<h2>Product/Process Change Notice (PCN)</h2>	
<input type="checkbox"/> Major Change <input checked="" type="checkbox"/> Minor Change	
PCN Number: PCN_PeBUCF_20250204 Affected Series: WP-BUCF Affected Part Number: 7461059 PCN Date: 2024-11-04 (YYYY-MM-DD) Effective Date: 2025-02-04 (YYYY-MM-DD)	Change Category: <input type="checkbox"/> Equipment/Location <input checked="" type="checkbox"/> General Data <input type="checkbox"/> Material <input type="checkbox"/> Process <input type="checkbox"/> Product Design <input checked="" type="checkbox"/> Shipping/Packaging <input type="checkbox"/> Supplier <input type="checkbox"/> Software
Contact: Product Management Phone: +49 (0) 7942 - 945 5001 Fax: +49 (0) 7942 - 945 5179 E-Mail: pcn.eican@we-online.com	Datasheet Change: <input checked="" type="checkbox"/> Yes <input type="checkbox"/> No Attachment: <input type="checkbox"/> Yes <input checked="" type="checkbox"/> No

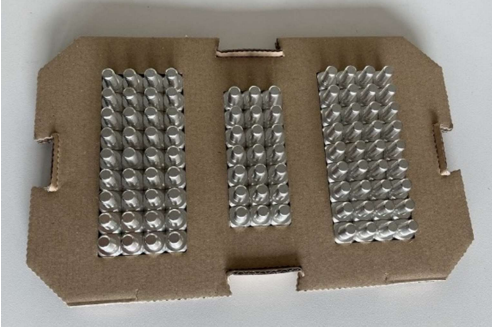
DESCRIPTION OF CHANGE: <p>Due to an improvement of the production capability, Würth Elektronik eiSos will change the packaging from carton to carton tray. The new carton will change the SPQ an CPQ.</p> <p>In addition, because of database mismatch the value of the total height is placed in brackets.</p> <p>There will be no change in form, fit, function, quality or reliability of the product.</p> <p>The new revision of the affected order codes will be sent out after the previous revision is out of stock (according to FIFO - first-in, first-out).</p>	
DETAILS OF CHANGE: <p>The new packaging will look like showed in the pictures below.</p>	
Before Change	After Change

Dimensions (LxWxH): 139.0 x 89.0 x 97.0 mm	Dimensions (LxWxH): 274.0 x 171.0 x 15.0 mm
